# Groundwater Application Review Summary Form

Application # G- 18535

TO: Water Rights Section Date August 22, 2017  
 FROM: Groundwater Section Aurora C Bouchier  
Reviewer's Name  
 SUBJECT: Application G- 18535 Supersedes review of na  
Date of Review(s)

**A. GENERAL INFORMATION:** Applicant's Name: Susan and Andy Hermreck County: Crooked

### Water-Level Trends in Nearby Wells

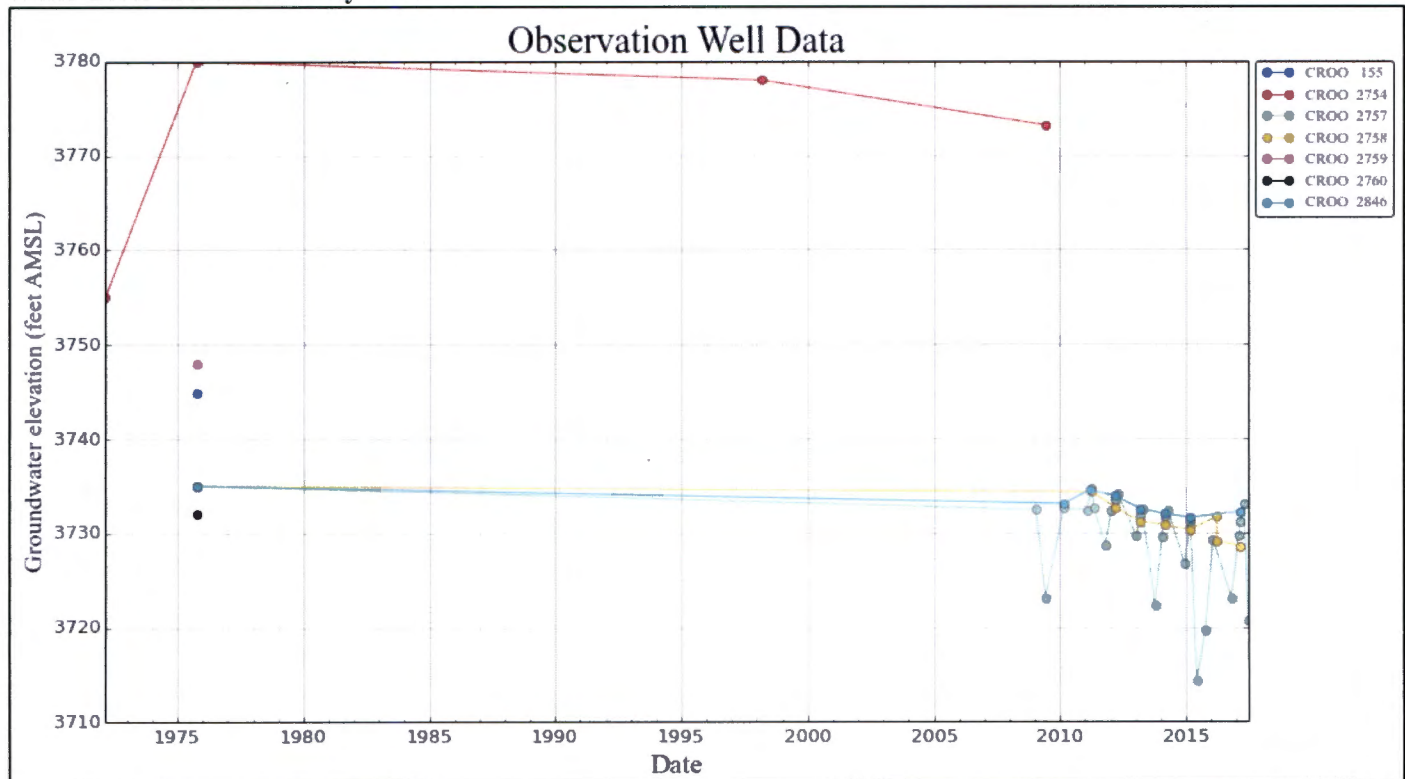
A large amount of groundwater has been permitted in a relatively small area of the Paulina Basin. The sustainability of the resource in the area, given the new development, is unknown. The groundwater resource is likely relatively small (in area) within the Paulina Basin. Historically, there have been no State Observation Wells in the vicinity of the new development. Three wells in the immediate area (Alkali Flat), CROO 2757 and CROO 2758 (authorized under Certificate 89752) and CROO 2846 (authorized under Certificate 89751), have annual, March, static water-level permit conditions with water-level reporting beginning in 2010. The hydrographs of these wells indicates that the annual (March) static water has fluctuated by two to four feet with no persistent trend. One of these wells, CROO 2757, is now a State Observation Well with quarterly measurements collected by OWRD staff. The quarterly measurements at CROO 2757 may indicate an increase in the seasonal fluctuation, or at least may show the groundwater stress during drought with a lower than normal summer water-level in 2015 (see hydrograph below).

Note, it appears that in the immediate vicinity the only well for which pump tests have been conducted is CROO 2754, with pump test exemptions being granted for the other wells. Upon closer examination, it appears that CROO 2754 may be producing, at least in part, from a different source than the other wells (see hydrograph and lithologic comparison below). A pump test on CROO 2759, or similar well, should be required.

### Pump Test Plot for CROO 2754/2761

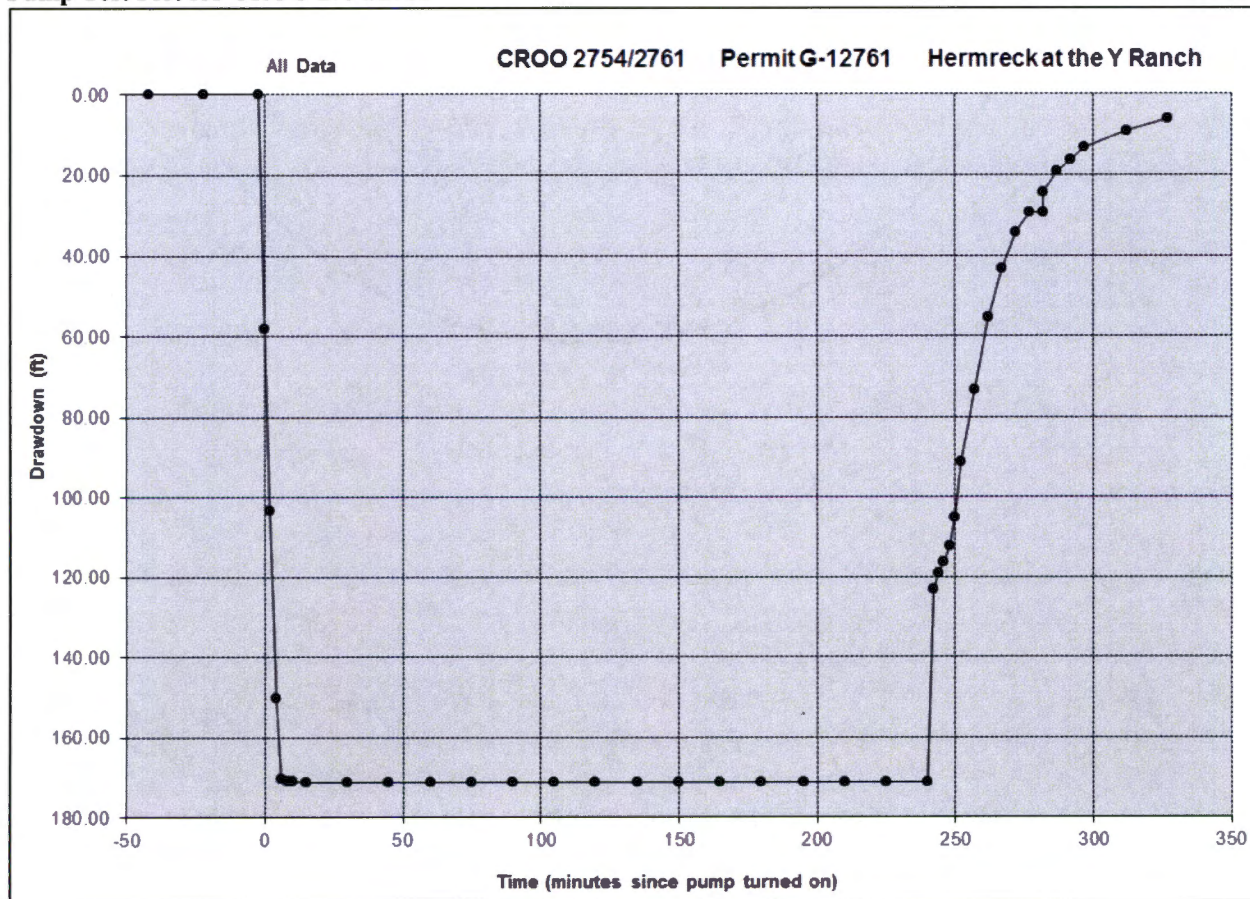
Alluvium, other sediments, and tuffaceous sedimentary rocks overly basalt in the Paulina Basin area. The basalt is likely vertically fractured to some degree, and ground water in the basalt may be hydraulically connected to the overlying sediments as evidenced by the numerous springs located along intermittent Alkali Creek. The canyon of Beaver Creek is locally cut in Picture Gorge Basalt, and likely provides an interconnection with surface water. This assertion appears to be corroborated by the pump test for CROO 2754 (deepened under CROO 2761) which shows a distinct leveling off of drawdown within the first 10-minurtes of pumping (see plot of pump test data below).

The canyon of Beaver Creek is locally cut in Picture Gorge Basalt, which likely provides an interconnection with surface water. This may be supported by the pump test for CROO 2754 (deepened under CROO 2761), which shows a distinct leveling off of drawdown within the first 10-minurtes of pumping (see plot of pump test data below).
